BLACKMAN HILLS SUBDIVISION

APPLICATION NUMBER 4 DATE March 9, 2017

REQUEST Subdivision

DETAIL SITE PLAN

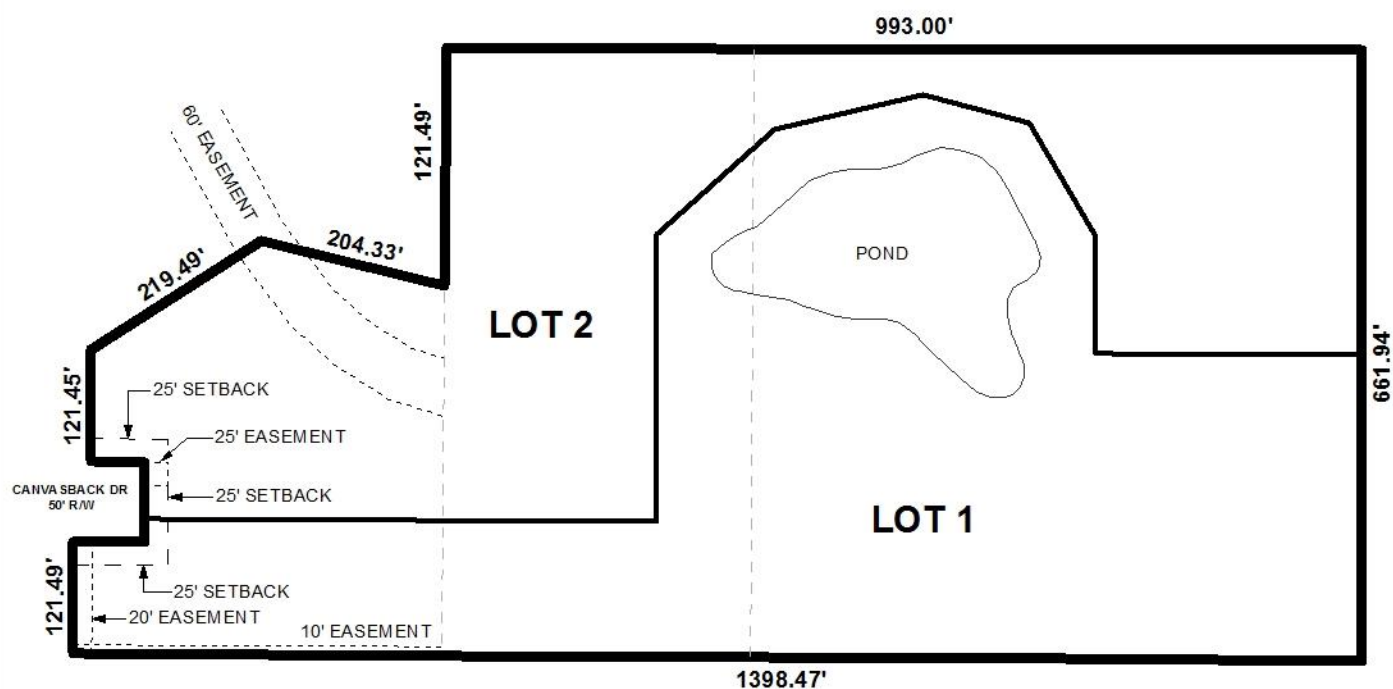
Each lot has frontage on Canvasback Drive, a minor street with curb and gutter requiring a 50' right-of-way width. The plat illustrates sufficient right-of-way dedication; therefore, no additional dedication should be required.

It should be noted that the width of the portions of the lots along which they each have frontage are large enough to be potentially re-subdivided and, in accordance with Section V.D.3. of the Subdivision Regulations, are not exclusive of unusable land, thus contributing to maximum depths more than 3.5 times the widths of the lots at their potential building lines. Such designs may also be regarded as "panhandle" lots, which are generally discouraged by Section V.D.1. of the Subdivision Regulations; the exception being the approval of lots located where varied and irregularly-shaped lot designs are common, and the informality of design is consistent with other lots in the vicinity. Planning Commission approval of various irregularly shaped lots within the immediate vicinity of the subject site, most notably Woodbridge Subdivision Unit 4 Phase B, to the North, may facilitate approval of this request; however, it should be noted that waivers of Sections V.D.1. and V.D.3. will be required. Also, a note should be required on the Final Plat stating further re-subdivision of the lots will not be allowed until additional public street frontage is provided.

Irrespective of their width-to-depth ratios and irregular designs, the proposed lots do exceed the minimum size requirements of the Subdivision Regulations and are appropriately labeled on the preliminary plat. The 25' minimum building setback line is also appropriately labeled for each lot on the preliminary plat. This information should be retained on the Final Plat, or a table indicating the same information should be provided on the Final Plat, if approved.

With regards to access management, a note should be placed on the Final Plat stating each lot is limited to one curb cut, with any changes in their sizes, designs, or locations to be approved by County Engineering and conform to AASHTO standards.

Multiple easements are illustrated on the preliminary plat, including: a 10' drainage easement in the South of proposed Lot 1; a 20' access easement in the West of proposed Lot 1; a 25' drainage easement within the 25' minimum building setback of proposed Lot 2; and a 60' drainage easement in the North of proposed Lot 2. As such, a note should be required on the Final Plat stating no structures will be constructed in any easement.

This site is located in the County, thus any lots which are developed commercially and adjoin residentially developed property must provide a buffer, in compliance with Section V.A.8. of the Subdivision Regulations. The note regarding this requirement should also appear on the Final Plat, if approved.

The site will have to comply with the City of Mobile storm water and flood control ordinances. A note stating *"Must comply with the Mobile County Flood Damage Prevention Ordinance. Development shall be designed to comply with the storm water detention and drainage facility requirements of the City of Mobile storm water and flood control ordinances, and requiring submission of certification from a licensed engineer certifying that the design complies with the storm water detention and drainage facility requirements of the City of Mobile storm water and flood control ordinances prior to the issuance of any permits."* should be placed on the Final Plat, if approved.

Based on the preceding, and with a waiver of Sections V.D.1. and V.D.3. of the Subdivision Regulations, this application is recommended for Tentative Approval, subject to the following conditions:

- 1) placement of a note on the Final Plat stating further re-subdivision of the lots to create additional lots will not be allowed until additional public street frontage is provided;

- 2) retention of the lot sizes in square feet and acres on the Final Plat, or the furnishing of a table on the Final Plat providing the same information;

- 3) retention of the 25' minimum building setback line along all frontages;
- 4) placement of a note on the Final Plat stating each lot is limited to one curb cut, with any changes in their sizes, designs, or locations to be approved by County Engineering and conform to AASHTO standards;

- 5) placement of a note on the Final Plat stating no structures will be constructed in any easement;
- 6) placement of a note on the Final Plat stating that any lots which are developed commercially and adjoin residentially developed property must provide a buffer, in compliance with Section V.A.8. of the Subdivision Regulations;

- 7) placement of a note on the Final Plat to comply with the Mobile County storm water and flood control ordinances (*Must comply with the Mobile County Flood Damage Prevention Ordinance. Development shall be designed to comply with the storm water detention and drainage facility requirements of the City of Mobile storm water and flood control ordinances, and requiring submission of certification from a licensed engineer certifying that the design complies with the storm water detention and drainage facility requirements of the City of Mobile storm water and flood control ordinances prior to the issuance of any permits.*); and
- 8) placement of a note on the Final Plat to comply with the Fire Department comments: (*Projects outside the City Limits of Mobile, yet within the Planning Commission Jurisdiction, fall under the State or County Fire Code (2012 IFC).*).
